OBJECTION TO PLANNING APPLICATION 2026/0447 from POSITIVELY HERSHAM, a sub- committee of HERSHAM COMMUNITY GROUP

This particular objection is in relation to HIGHWAY AND FOOTWAY WORKS along Burwood Road.

The Plan showing the current proposal is BWR-RGP-XX-XX-DR-T-002, updated 2 July 2026.

DRAWINGS OF PROPOSALS TO SCALE

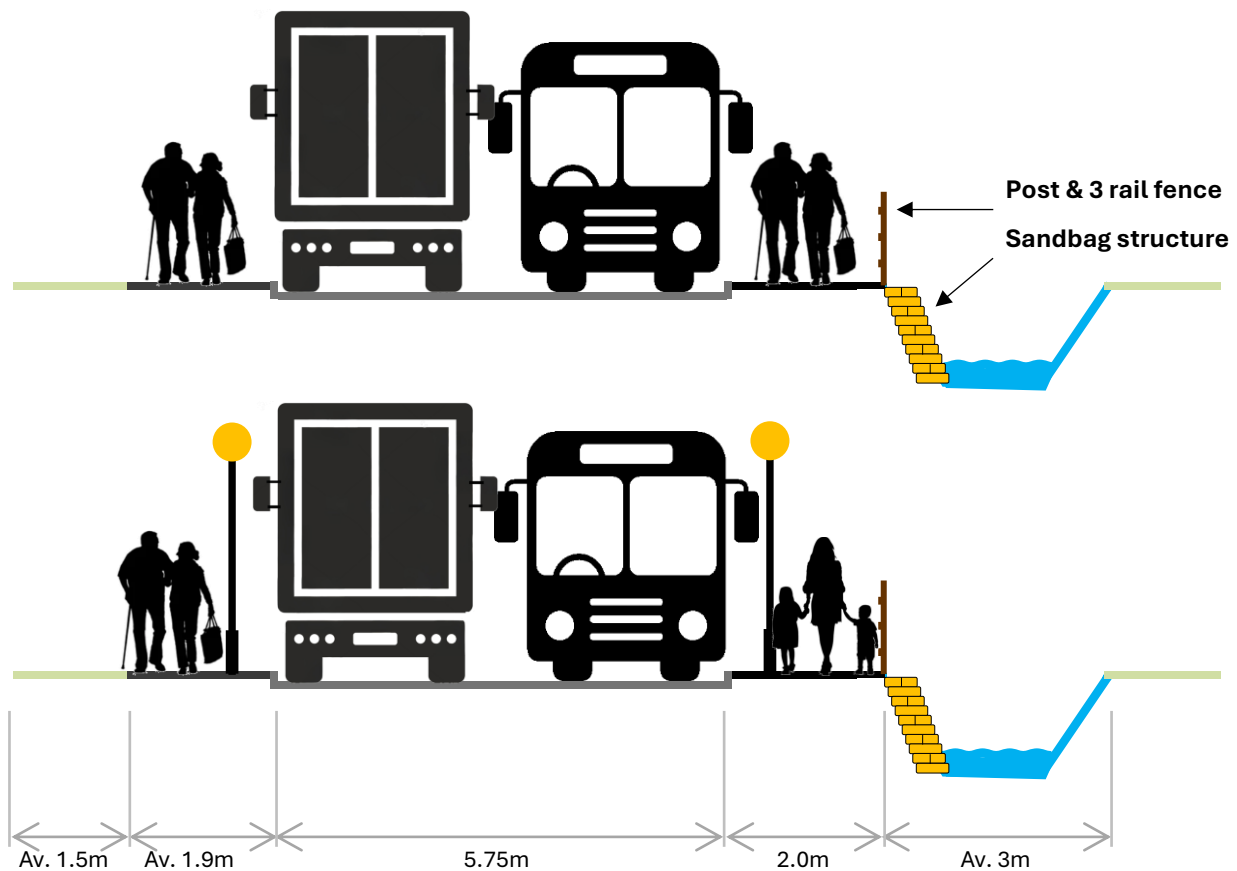
The **minimum** width should be **at least** 2m. The proposed 2m width only runs from the new estate entrance to the crossing point and then tapers down to 1.5m onwards to Vaux Crescent. Due to the statutory placing of illumination poles at the crossing point, the useable path width is reduced to approximately 1.25m. At crossing points, wheelchair users require turning space, as do mothers with child buggies. Using the crossing to access the new path is impossible as the necessary turning space does not exist.

Furthermore, where a barrier is proposed (as in this case) the minimum footpath width has to increase, depending on the height of the barrier. This particular barrier, as proposed, results in a minimum width increase of 0.25m, to a width of **at least** 2.25m.

It is also noted, with very considerable concern, that the Applicant has now resorted to proposing a narrowing of the highway by 0.25m in an attempt to find a bit of extra land for the footway. This proves, beyond doubt, that there is a very big problem here. See below, under HIGHWAY.

It is also noted that it is proposed to install a form of cement sandbag barrier as a retaining wall. We are not aware if a soil survey has been undertaken but it seems unlikely. This land is really soft - just walking on it will demonstrate the problem - and it is incapable of supporting such a structure.

The barrier, as noted above, is a wooden post and 3 rail, with no tapping rail for the visually impaired. Given the immediate potentially dangerous environment, the design of the barrier and the materials, this is simply inappropriate. Wood will not last very long and will rot quickly, becoming even more dangerous bearing in mind this is the only barrier on the edge of a very narrow path. A barrier must also be outside the footprint of the path. In this case the design of the barrier falls foul of recommendations. It fails on every level and the consequences of such failure may be catastrophic.

As noted above, it is proposed to reduce the width of the highway to 5.75m. The following should be noted:

- A new road such as Burwood Road, if built now, would be 6.5m wide so it should not even be contemplated to reduce the width.
- A bus route, which Burwood Road is, must have a minimum 6.0m.
- The current maximum width of most buses, HGVs and other road vehicles is 2.85m. 2 passing vehicles of this size require 5.7m plus space to avoid collision. This leaves 5cm. **This is unacceptable.**
